26 March 2025

## Submission – Proposed Planning Scheme Amendment C265case

SPOT Planning continues to act on behalf of Amazon International Investment Consortium Pty Ltd with respect to their interest in the following properties within the future Casey Fields South (Employment) and Devon Meadows Precinct Structure Plan area:

Recommended refinements

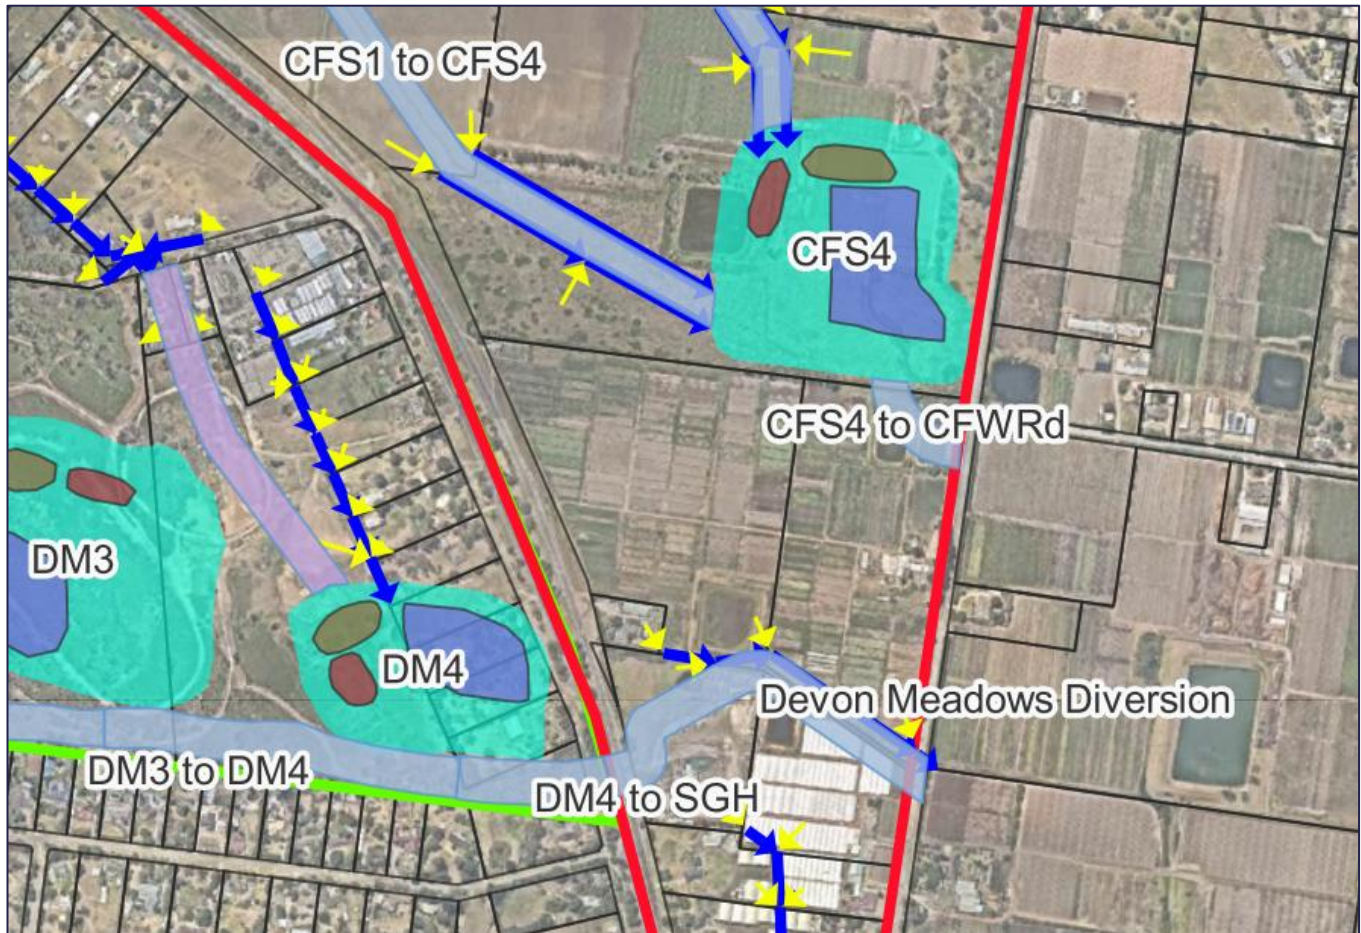
*In summary, it is submitted that Table 4 of the PSP be further refined as per the track changed recommendations below, to encourage development that may be as of right in appropriate circumstances within the Light Industry area.*

Track Changed Recommendation
Applies to land located within the 'Light Industry' area shown on Plan 8 - Employment and Activity Centres. The light industry area is generally located around the periphery of the precinct where it is important that new employment activities are compatible with more sensitive land uses.
The area is envisaged as having a smaller scale and more articulated style of built form that will providing a transition between larger format activities internal to the precinct and adjoining residential land. <u>Development within the Light Industry area may provide for a combination of smaller format and larger format activities, subject to the location and context.</u>
<b>Activity</b> A range of activities that do not generate significant adverse amenity effects are expected to establish in the Light Industry area, including but not limited to: <ul style="list-style-type: none"> <li>• Small scale manufacturing</li> <li>• Service industries</li> <li>• Research and development</li> <li>• <u>Warehousing and storage of goods</u></li> </ul>

*Plan 9 – Infrastructure and Development Staging*

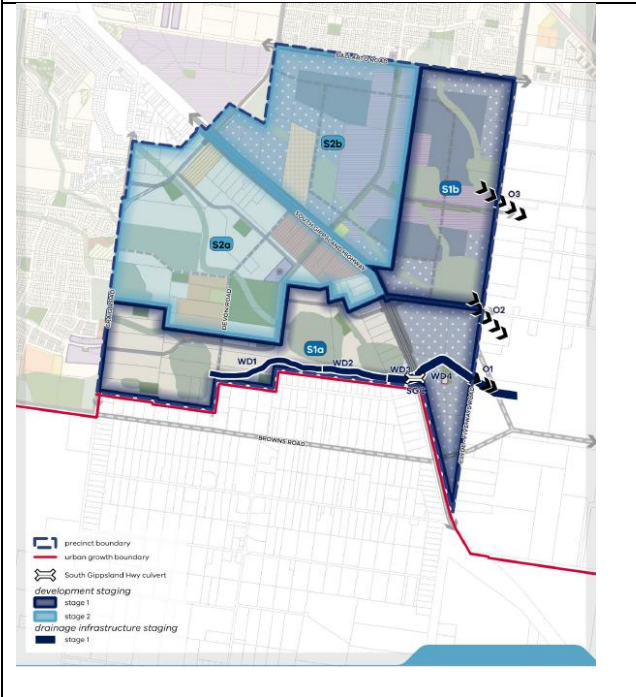
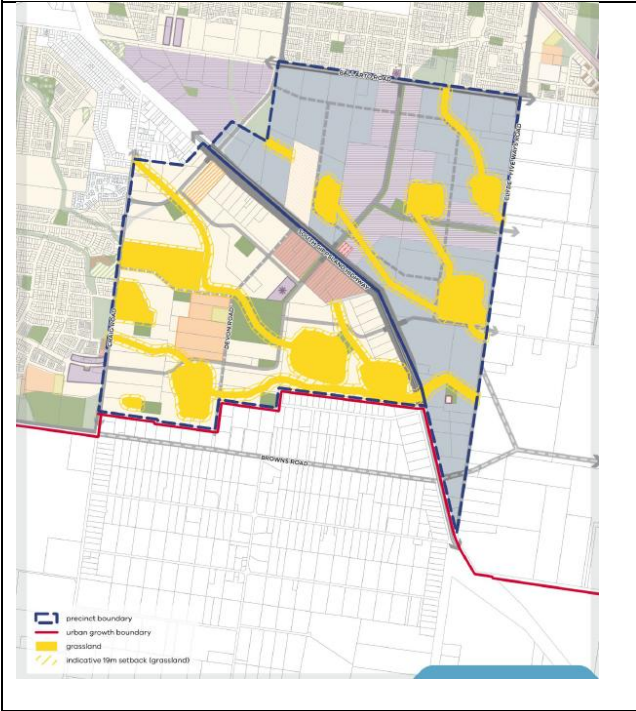
As such, without empirical justification to support the proposed Plan 12 – Infrastructure and Development Staging, the provisions should be removed from the draft Melton East Precinct Structure Plan.

The current controls limit the ability to investigate innovative interim drainage solutions that may unlock land whilst providing for a sufficient short-medium term drainage solution.

*In summary, this submission seeks the removal of Plan 9 – Infrastructure and Development Staging from the PSP, noting there is no empirical justification for the staging boundaries and the controls prevent innovative interim drainage solutions. They provide little to no value above and beyond the regular sequencing and subdivision requirements and guidelines.*
